TEALING TO KINTORE UPGRADE PROJECT (TKUP) — reference TRL-120-1

WRITTEN RESPONSE on behalf of NOTKUP TO PROCEDURE NOTICE DATED 7 JULY 2026

MATTER 7: MAJOR ACCIDENT HAZARD GAS PIPELINE PART 1

16 August 2026

27 SSEN public consultation

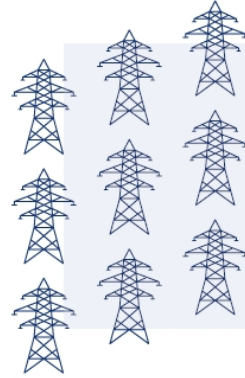
In the SSEN consultation document Tower Crossings Considerations⁵ they acknowledge their awareness of the existence of risk to the safe operation of pipelines if overhead lines run close and parallel to pipelines and how it is important to cross at right angles.
